# Access Compliance Report

## Public Rights-of-Way (Curb Ramps)

Intersection ID: 31771	Main Street: STARNES RANDALL RD	Cross Street: PINYON PINE LN	Location: SE
ADA ID: 2283CD852890	Ramp Type: Perp	Initial Pass/Fail: Fail	Overall Compliance: No
		Severity Score: 35

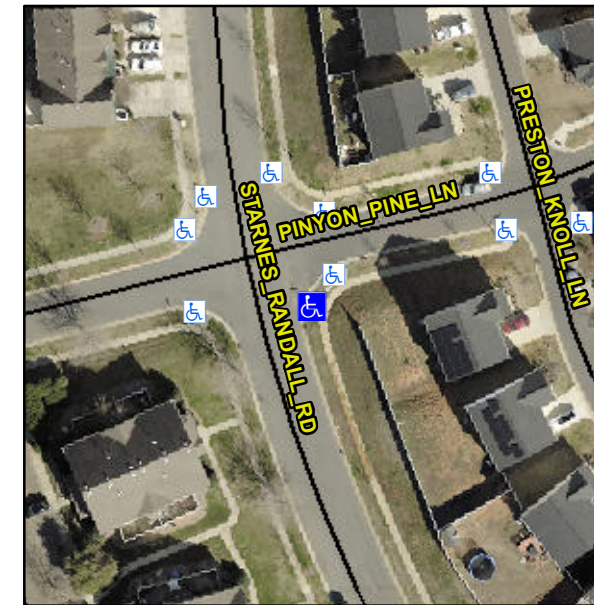
**Not Found, R304.5.1**

Compliance	Description	Data	Compliance	Description	Data
N/A	Ramp Length (in)	91.0	Yes	Ramp Slope (%)	7.1
No	Ramp Width (in)	24.0	Yes	Ramp XSlope (%)	1.4
N/A	Flare Type LT	N/A	N/A	Flare Type RT	N/A
N/A	Flare Slope LT (%)	N/A	N/A	Flare Slope RT (%)	N/A
N/A	Flare Traversable LT?	N/A	N/A	Flare Traversable RT?	N/A
N/A	Landing Length (in)	N/A	N/A	DWS Provided?	N/A
N/A	Landing Width (in)	N/A	N/A	DWS Contrast?	N/A
N/A	Landing Slope (%)	N/A	N/A	DWS Length (in)	N/A
N/A	Landing X Slope (%)	N/A	N/A	DWS Full Width?	N/A
N/A	Landing Curb? (Y/N)	N/A	N/A	DWS Offset (in)	N/A
N/A	Shared Landing?	N/A			
N/A	Gutter Ponding?	N/A	N/A	Gutter Slope (%)	N/A
N/A	Gutter Lip Ht (in)	N/A	N/A	Gutter X Slope (%)	N/A
N/A	Painted X Walk1?	No	N/A	Painted X Walk2?	N/A
	X Walk 1 Direction	To W		X Walk 2 Direction	N/A
N/A	X Walk 1 Width (in)	N/A	N/A	X Walk 2 Width (in)	N/A
	X Walk 1 Slope (%)	2.4		X Walk 2 Slope (%)	N/A
	X Walk 1 X Slope (%)	2.2		X Walk 2 X Slope (%)	N/A

**Remove & Replace Entire Ramp.**
